## 1. Modifications with respect to RfP

## 2. Pre-Bid Clarifications

### 3. Drawings of SMC Box

#### 1. Drawing of SMC Single Phase Meter Box

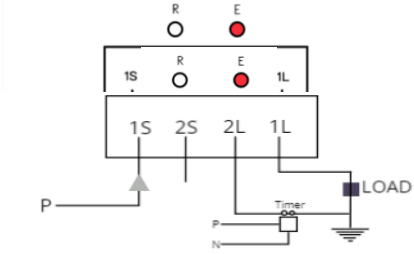
S. No.	Page/ clause no.	Clause as per RFP	Bidder's Query	Clarification to Bidders
				the bidder has to inform for such requirement to the local office of DISCOM after survey and DISCOM will provide and replace
20	Page 283. Appendix A.2	Single phase Whole Current meter SMC box drawing	In appendix only drawing of SMC meter box is attached, which is also very unclear. If SMC box is required then kindly provide technical specification of the SMC meter box with clear drawing.	The dimensions of SMC Boxes for meters is mentioned in Annexure M. The Drawings are attached again as a part of Corrigendum. Refer Point 3 of Corrigendum.
21	Page 291. Appendix B.2	3 phase Whole Current meter SMC box drawing	In appendix only drawing of SMC meter box is attached, which is also very unclear. If SMC box is required then kindly provide technical specification of the SMC meter box with clear drawing.	The dimensions of SMC Boxes for meters is mentioned in Annexure M. The Drawings are attached again as a part of Corrigendum. Refer Point 3 of Corrigendum.

22	Page 297. Appendix C.2	3 phase LTCT meter SMC box drawing	In appendix only drawing of SMC meter box is attached, which is also very unclear. If SMC box is required then kindly provide technical specification of the SMC meter box with clear drawing.	The dimensions of SMC Boxes for meters is mentioned in Annexure M. The Drawings are attached again as a part of Corrigendum. Refer Point 3 of Corrigendum.
23	Page 300-Annexure –F <b>General requirement for common pluggable communication module for Smart Meters.</b>	Thus in order to enable different communication modules to be used in the same meter, it is necessary to use a universal interface and a particular size irrespective of the choice of communication technology that defines the dimensions of the communication slot as well as physical placement and location of connectors	Every meter manufacturers have their own size and mounting arrangements of NIC module. The NIC module size, fixing arrangement and connection with the meter shall vary from different manufacturer to manufacturer. So, it shall be impossible to integrate/ interoperate the NIC module of various manufacturers unless otherwise it shall require NEW DEVELOPMENT of every meter manufacturer. Therefore we request to kindly delete the requirement.	RfP conditions shall prevail

## 5. APPENDIX- B.1 TAMPER CONDITIONS FOR THREE PHASE WHOLE CURRENT METER, Page-286

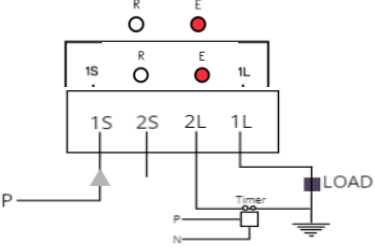
S. No.	Page/ clause no.	Clause as per RFP	Modified Clause
9	APPENDIX- B.1 TAMPER CONDITIONS FOR THREE PHASE WHOLE CURRENT METER, Page-286		<i>*New Condition Added*</i>  <i>Please Refer Point 5</i>
10	APPENDIX- C.1 TAMPER CONDITIONS FOR THREE PHASE LTCT SMART METERS, Page-292		<i>*New Condition Added*</i>  <i>Please Refer Point 6</i>
11	Section 6 Project Requirement, 1.4 Brief Scope of Work, D, Page-166	D. Consumer indexing on de-novo basis for contiguous electrical locations in the selected AMI Project Area along with its regular updates during contract period as per Clause 4 of this Section;	D. Consumer indexing on de-novo basis for  i. Contiguous electrical locations in the selected AMI Project Area along with its regular updates during contract period as per Clause 4 of this Section. <b>ii. Non-contiguous electrical locations, i.e., Consumer indexing with DTs on de-novo basis along with its regular updates during contract period as per Clause 4 of this Section; and feeder to DT indexing on de-novo basis for all DTs in along with its regular updates during contract period as per Clause 4 of this Section.”</b>  <i>(Reference to Addendum issued by REC dated 28.09.2022 vide Letter No: REC/PMD/AMISP/2022-23/270)</i>

## **8. Annexure T Specification of Polycarbonate Seals, Page-349**

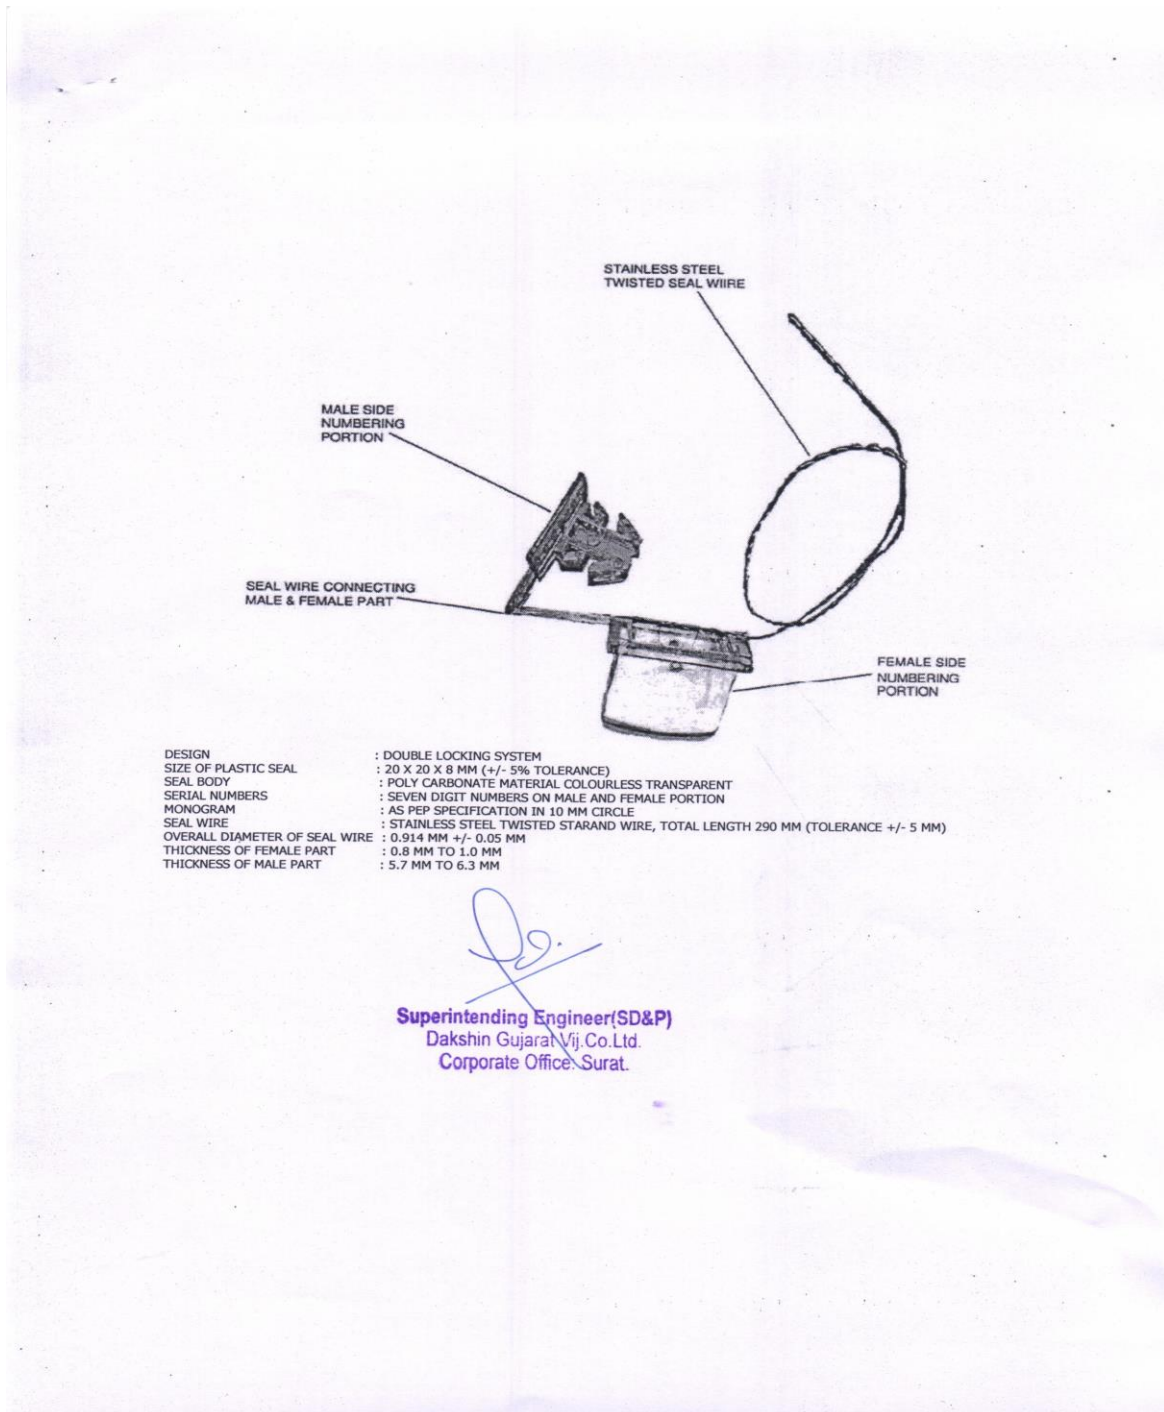
S. No.	Page/ clause no.	Clause as per RFP	Modified Clause
18	Annexure T Specification of Polycarbonate Seals, Page- 347		<p><i>Attaching the seal specifications for DGVCL as a part of Annexure T.</i></p> <p><i>The same is incorporated as per Point 8 of the corrigendum.</i></p>
